Tahlequah Casino Addendum 17

Date: July 20, 2018

Electrical

CHEROKEE NATION ENTERTAINMENT
TAHLEQUAH CASINO
TAHLEQUAH, OKLAHOMA

DATE: 03/27/18
 SHEET NO.: E0.10
 PROJECT: SINGLE LINE DIAGRAM - MAIN SERVICE SWITCHBOARD TCMSA

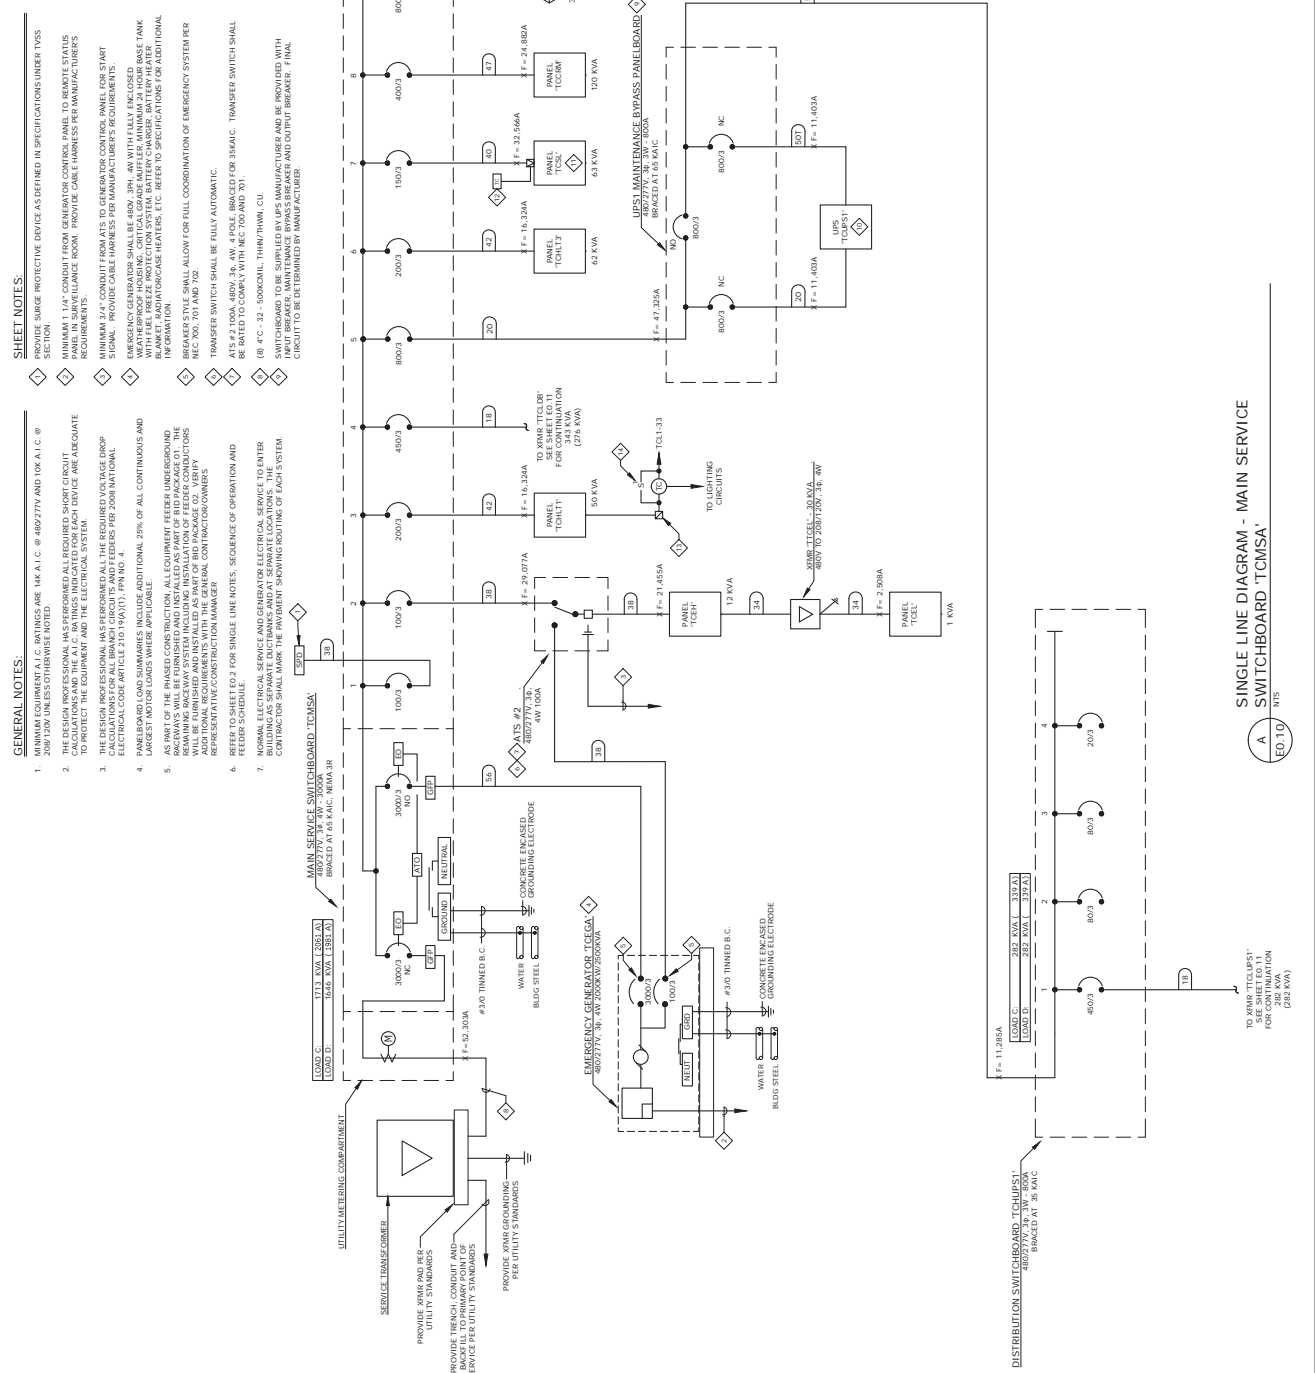
<u>Sheets</u>	<u>Description</u>
E0.0	Updated drawing index.
E0.10	Revised single line diagram as indicated.
E0.11	Revised single line diagram as indicated.
E0.12	Revised single line diagram as indicated.
E0.13	Revised single line diagram as indicated.
E0.14	Revised single line diagram as indicated.
E0.15	Revised single line diagram as indicated.
E0.20	Revised panel schedules as indicated.
E0.21	Revised panel schedules as indicated.
E0.23	Revised panel schedules as indicated.
E0.24	Revised entire sheet.
E0.25	Revised panel schedules as indicated.
E.026	Revised panel schedule as indicated.
E0.30	Revised dimmer panel schedules as indicated.
E0.31	Revised dimmer panel schedules as indicated. Added Sheet Note 1 as indicated.
E0.41	Revised lighting fixture schedule as indicated.
ES1.0	Added underground primary electrical conduit as indicated.
E1.0	Relocated/deleted electrical equipment and equipment callouts as indicated.

ENLARGED POWER PLAN - GAMING
E1.1
1/4" = 1'-0"
0 2 4 6 8 10
NORTH

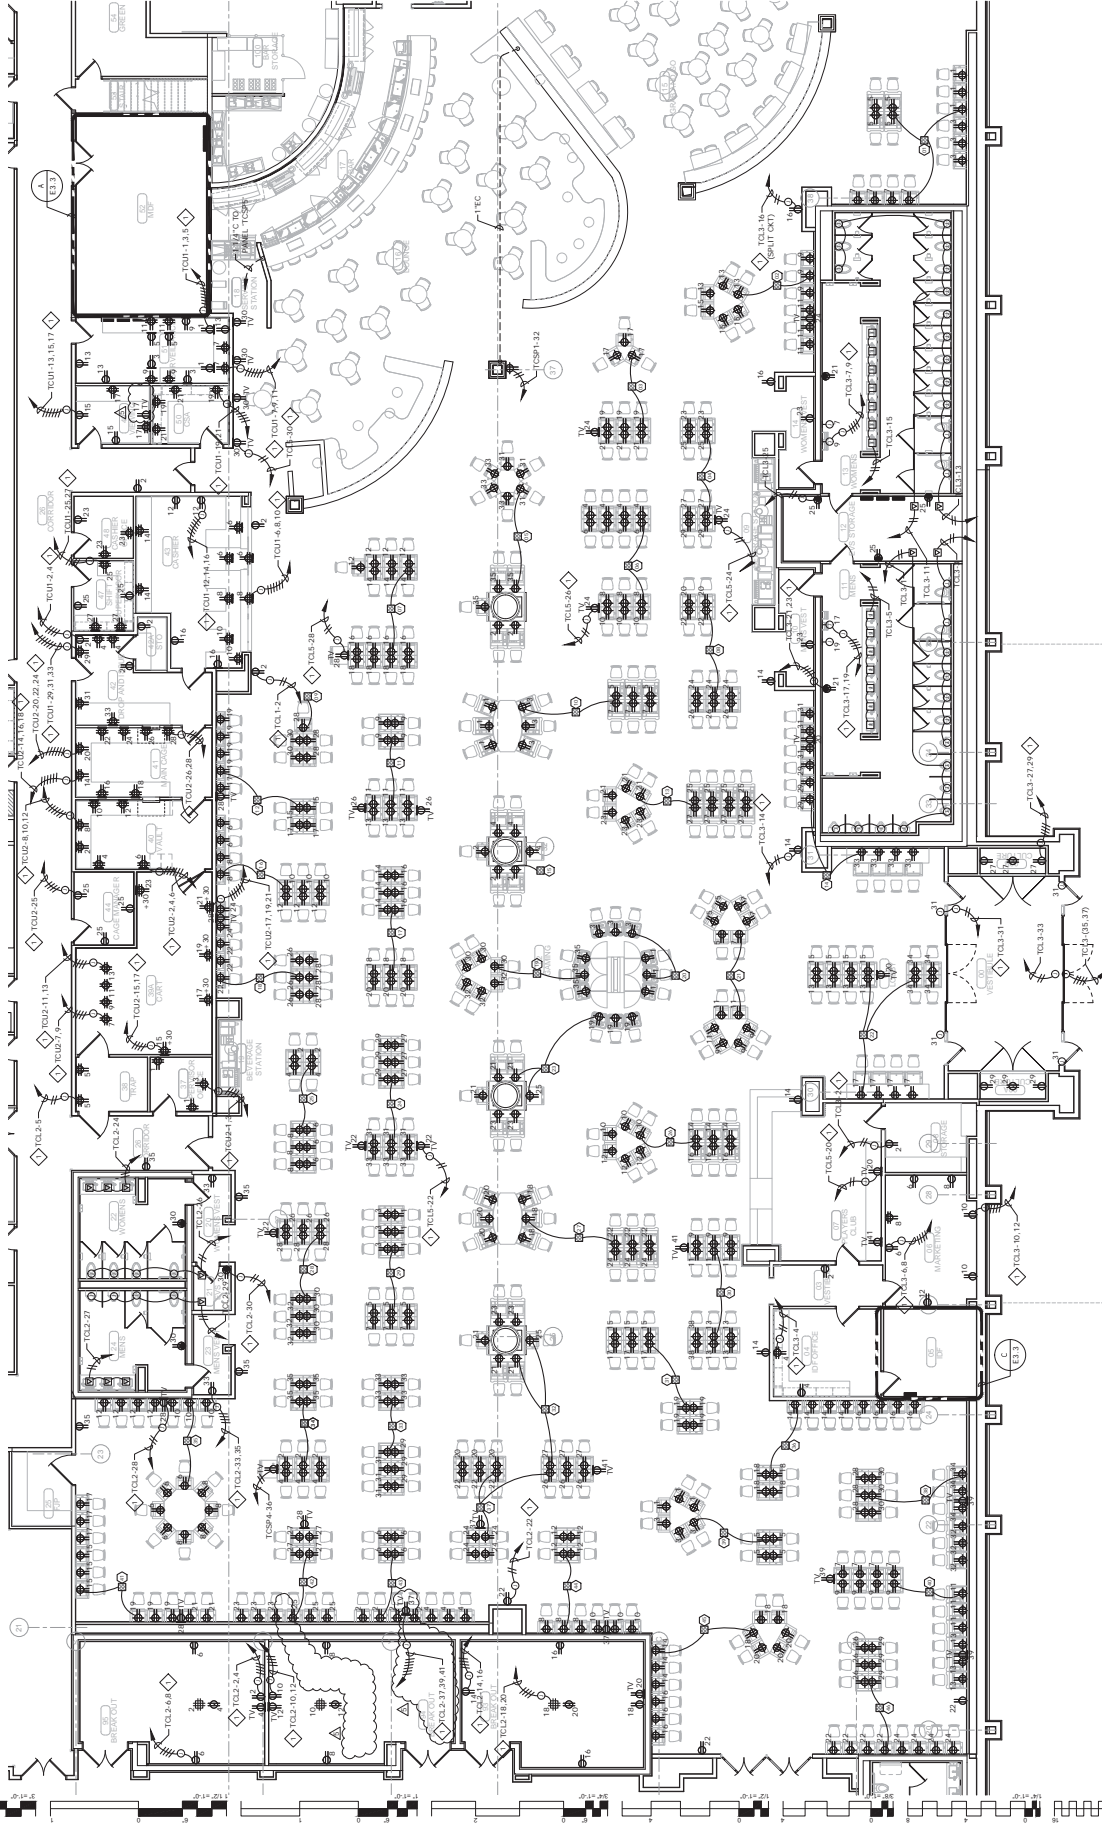
E1.1	Added/deleted/relocated outlets and circuiting as indicated based on owner AV review.
E1.2	Added/deleted/relocated outlets and circuiting as indicated. Added sheet notes as indicated.
E1.2M	Added/deleted/relocated electrical equipment as indicated.
E1.3	Added/deleted/relocated electrical equipment as indicated.

A ENLARGED MECHANICAL POWER PLAN - BOH
E1.3M
1/8" = 1'-0"

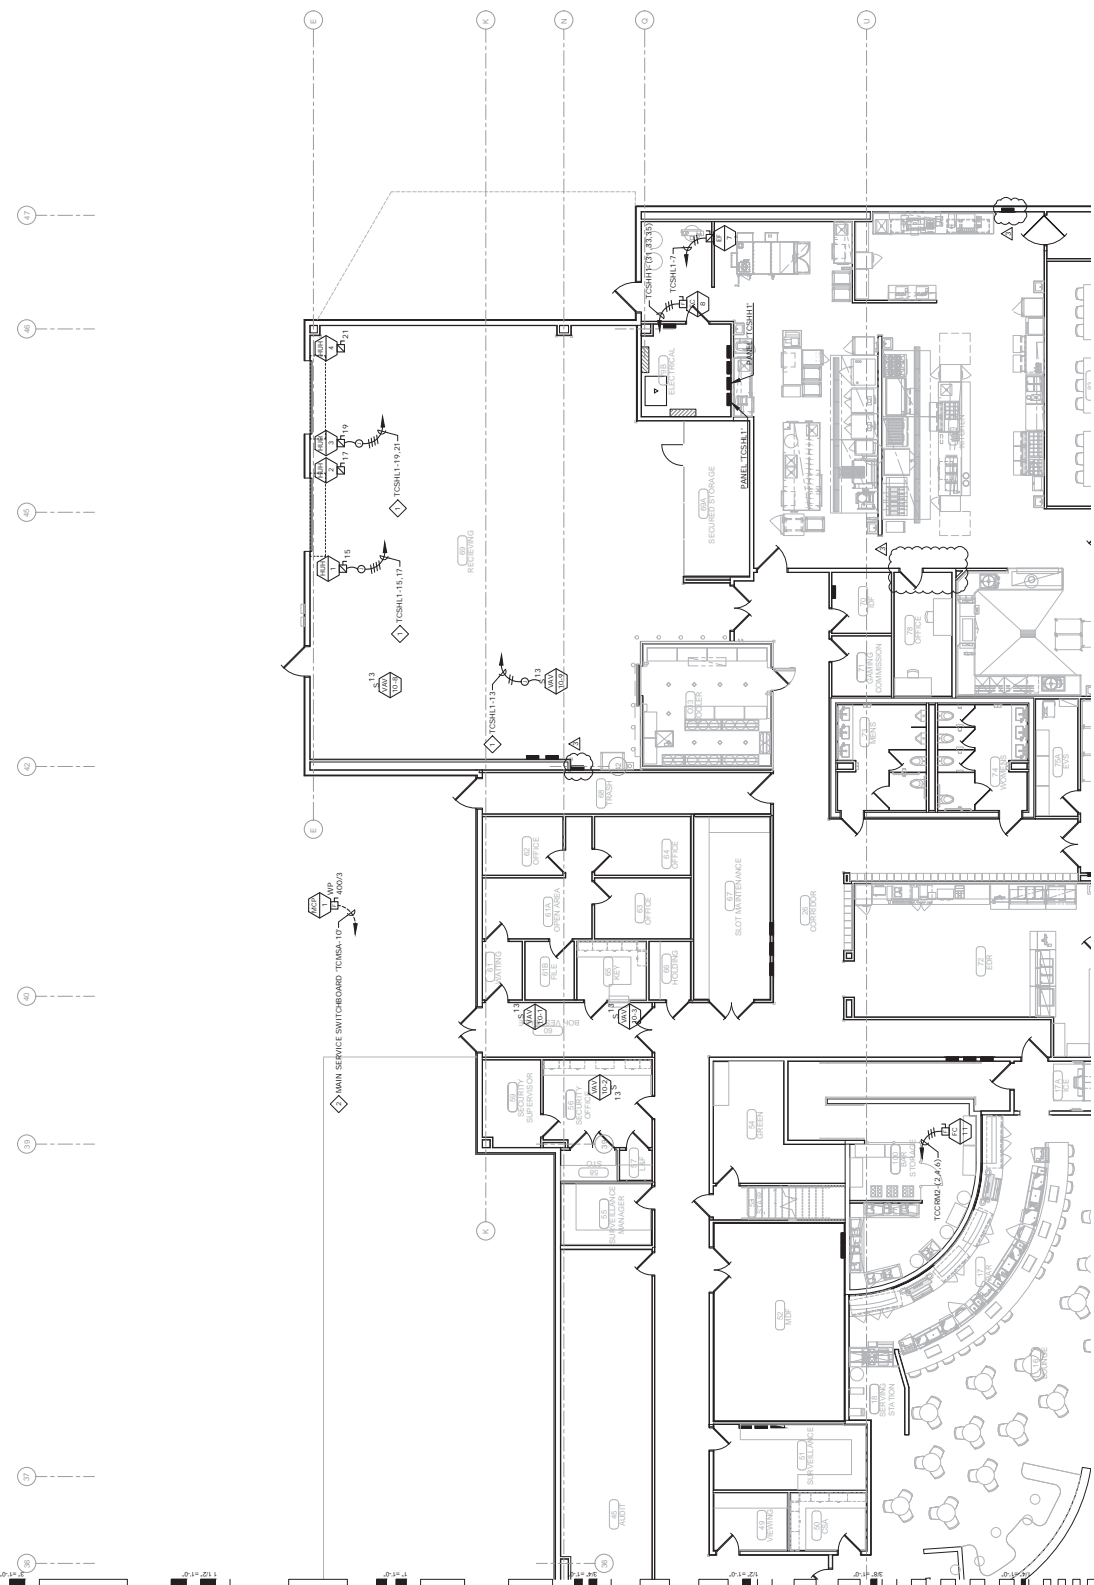
- E1.3M Added/deleted/relocated electrical equipment as indicated.
- E1.4 Deleted outlets and circuiting as indicated.
- E1.5 Revised sheet notes as indicated.

A POWER PLAN - ROOF
E1.6 1" = 20' 0"

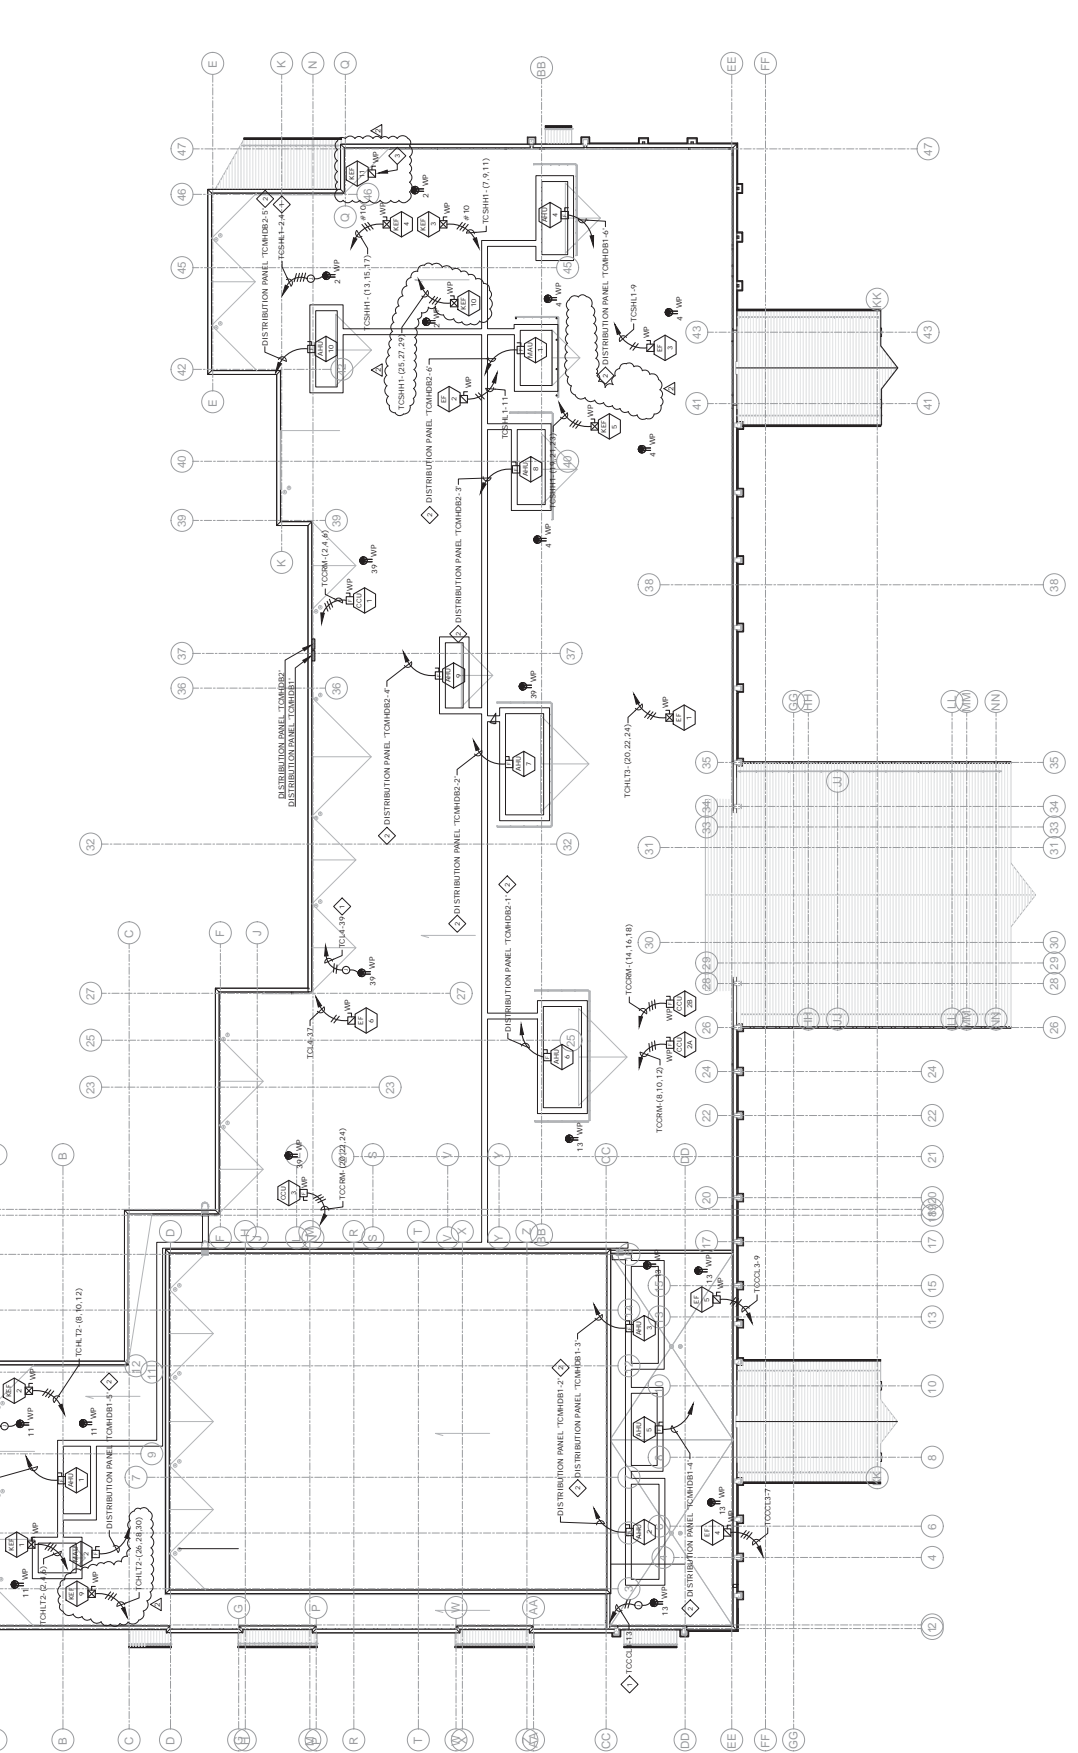
- E1.6 Added deleted/relocated electrical connections to mechanical equipment based on mechanical design coordination. Added Sheet Note 3 as indicated.

DATE: 05/03/18
DRAWING NO.: 17-06
PROJECT NAME:
E6.1
ENLARGED LIGHTING PLAN - GAMING

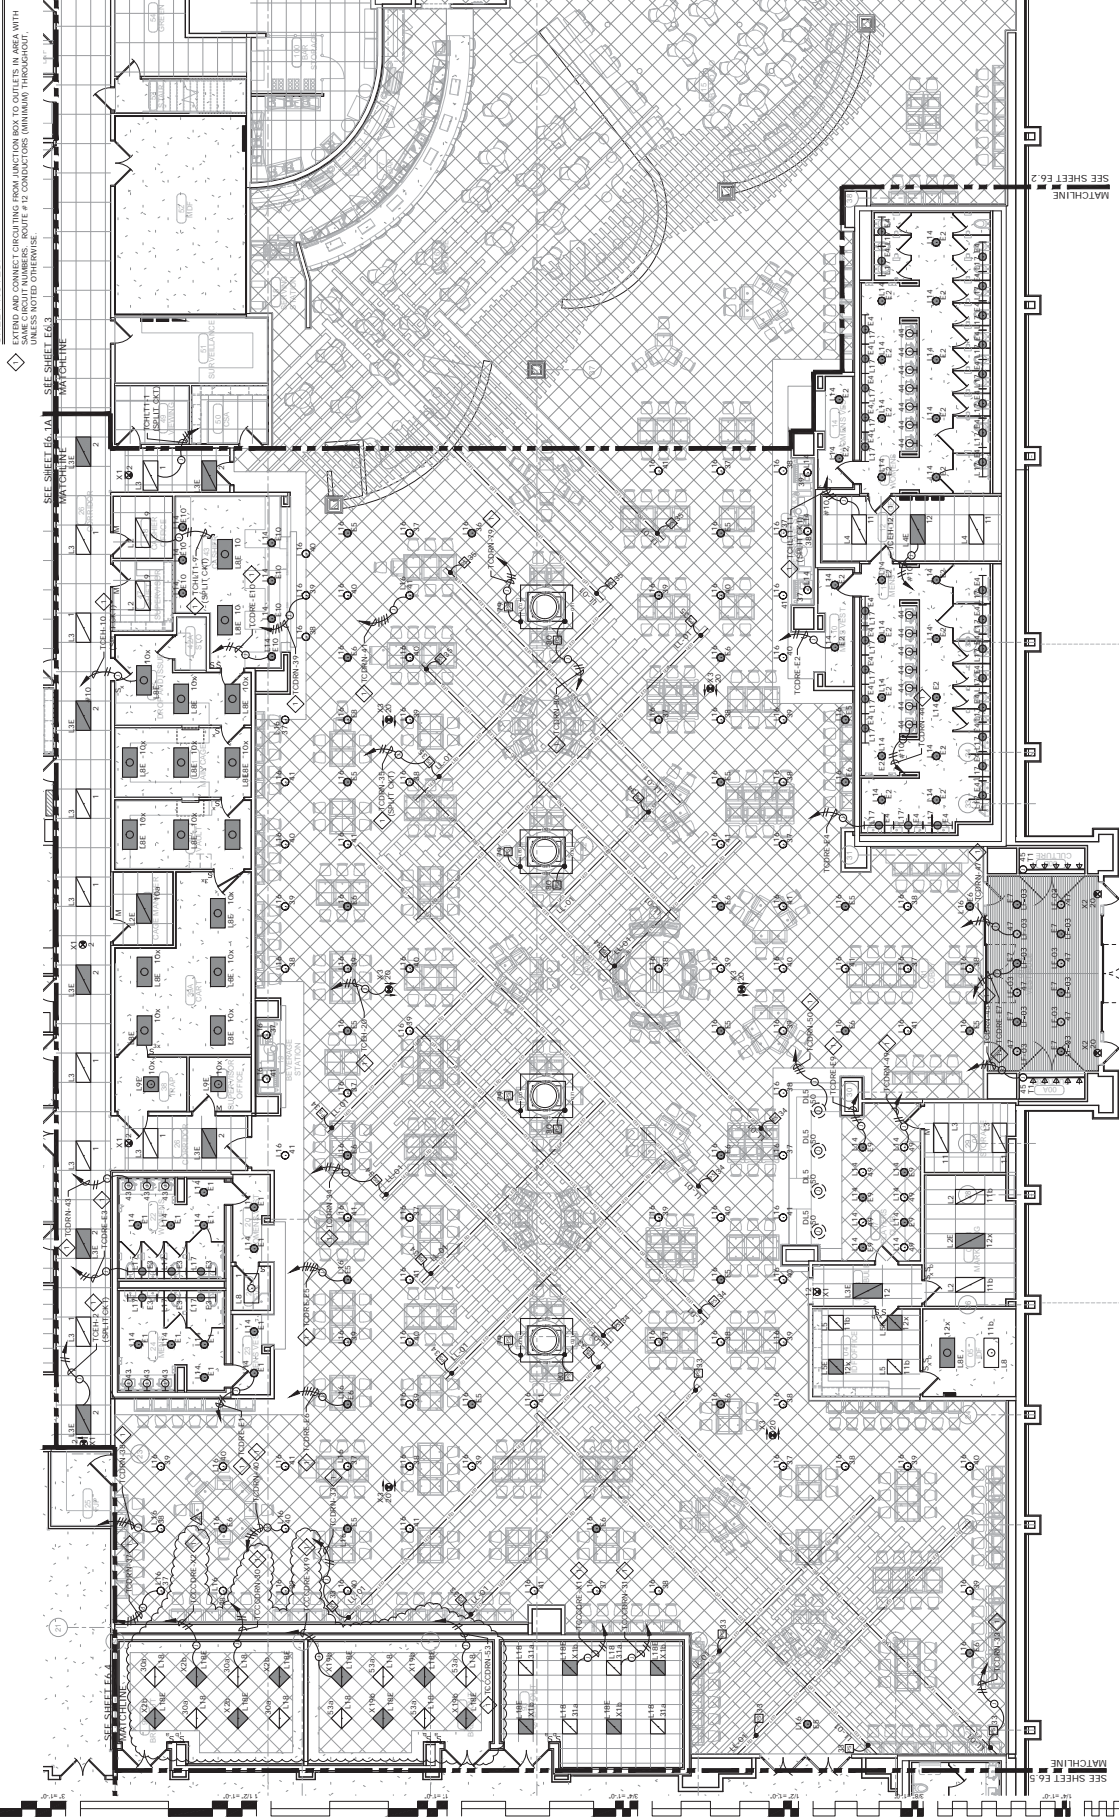
- E6.1 Added/deleted/relocated light fixtures, switches and circuiting based on updated architectural backgrounds.
- E6.2 Revised entire sheet.
- E6.3 Revised architectural background.
